ND-17-0113
10 CFR 50.55a

Southern Nuclear Operating Company
Vogtle Electric Generating Plant Units 3 and 4
Response to Requests for Additional Information Related to
Preservice Inspection Requirements for Steam Generator Nozzle to
Reactor Coolant Pump Casing Welds (VEGP 3&4-PSI-ALT-05) Rev. 1 Supplement 1

**Additional Information Regarding AP1000 Vogtle Units 3 & 4 and V. C. Summer Units 2 & 3
Steam Generator to Reactor Coolant Pump Suction Nozzle Weld Flaw Evaluation**

Figure 1: Schematic of AP1000 Steam Generator and Reactor Coolant Pump Inspection Region

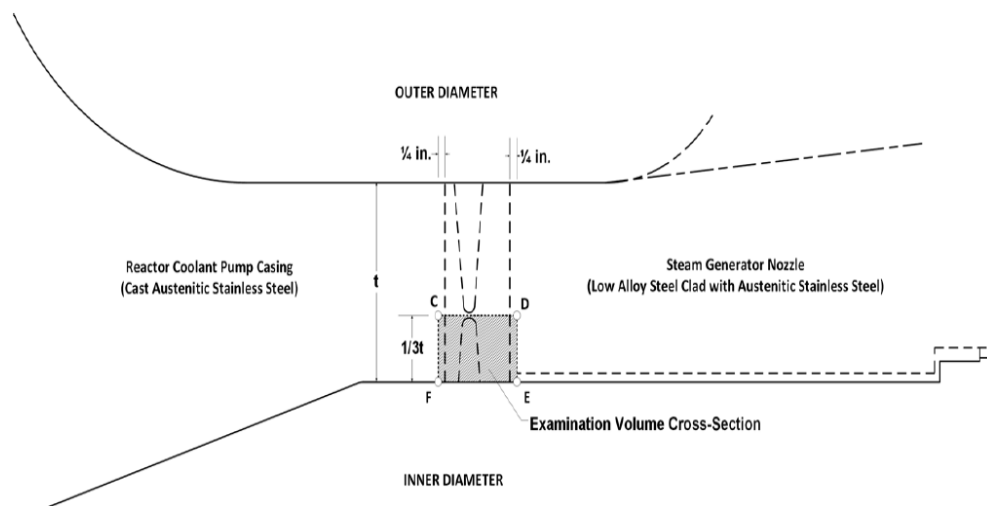
On January 13, 2017, a clarification call was conducted and SNC agreed to provide additional information justifying the use of constant flaw aspect ratios for axial and circumferential flaws included in Enclosure 3 of Response to Requests for Additional Information Related to Preservice Inspection Requirements for Steam Generator Nozzle to Reactor Coolant Pump Casing Welds (VEGP 3&4-PSI-ALT-05) Rev. 1 [ML16355A222]. In addition, SNC agreed to provide additional information justifying why only flaw depth was evaluated in determining flaw growth acceptability in the same enclosure.

1. Additional information regarding justification of the constant flaw aspect ratios (AR) of 2 and 6 for axial and circumferential flaws in Reference 1 is provided below.

For the postulated axial flaw, the analysis in Reference 1 considers an $AR = 2$ (flaw length/flaw depth). This flaw shape is based on the understanding that in the DM (dissimilar metal) weld, the axial flaw will follow the characteristic shape of the DM weld width and thickness. The DM weld inspection volume consists of the width of the dissimilar metal weld and the Heat Affected Zone (HAZ) – see Figure 1. The width of the dissimilar metal weld is approximately []^{a,c,e} based on the AP1000 steam generator and pump drawings. The inspection volume includes the ¼” examination zones adjacent to the weld on either side to account for the HAZ. Therefore, the total width of the DM weld inspection region is approximately []^{a,c,e}. The weld thickness is []^{a,c,e} (Reference 1). Therefore the shape or aspect ratio of the weld is 0.6 []^{a,c,e}, thus an aspect ratio of 2 is sufficiently large to account for any existing and hypothetical axial flaws.

Also, based on the fabrication ultrasonic testing (UT) results, the flaw aspect ratios that are observed are bounded by the analyzed aspect ratio of 2 for axial flaws. For example, based on the available axial flaw UT results for the AP1000 Vogtle and V. C. Summer units, [

For the postulated circumferential flaw, the analysis in Reference 1 considers $AR = 6$ (flaw length/flaw depth). This flaw shape is a typical aspect ratio for various applications in fracture mechanics. For instance, the Pressure Temperature (P-T) limits evaluation in ASME Section XI Appendix G also considers postulated flaw shapes to have an aspect ratio of 6:1. Industry experiences have also shown that the flaws found in-service are typically below $AR = 6$ (on the order of $AR = 2$ to 4 or even less). It should be noted that the AP1000 steam generator to pump DM weld region does not experience any high thermal stratification, as evident by the minimal fatigue usage discussed in Section 3 of Reference 1; therefore, there is low susceptibility for any fatigue crack initiations or propagation of existing fabrication indications. Therefore, the aspect ratio of 6 is sufficient to account for any existing and hypothetical circumferential flaws.

Also, based on the fabrication ultrasonic testing results, the circumferential flaw aspect ratios that are observed are bounded by the analyzed aspect ratio of 6 for circumferential flaws. For example, based on the available circumferential flaw UT results for the AP1000 Vogtle and V. C. Summer units, [
